FIRE SAFETY INSPECTION REPORT

Vintage Denim Apparels Ltd. (Wet Processing)

ACCORD ID: 23076

Fire Safety Inspection Report

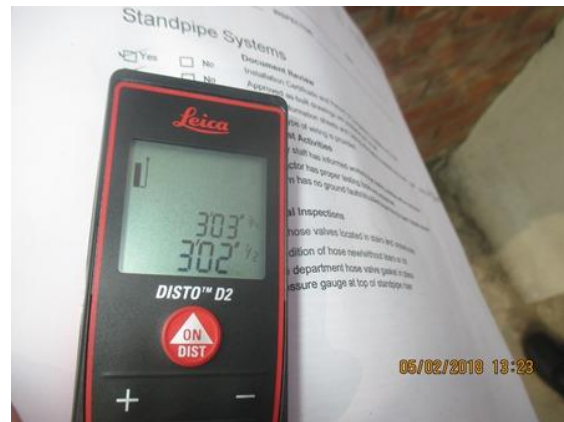
F-5	Fire Rated Construction	The chemical store on washing building ground floor not provided with adequate fire separation.	Separate chemical store rooms with 2- hr rated construction. Seal all penetrations and protect the openings to maintain the required fire separations. Keep 16-points MSDS of all chemicals in the storage area.	Within 3 months
-----	-------------------------	---	--	-----------------
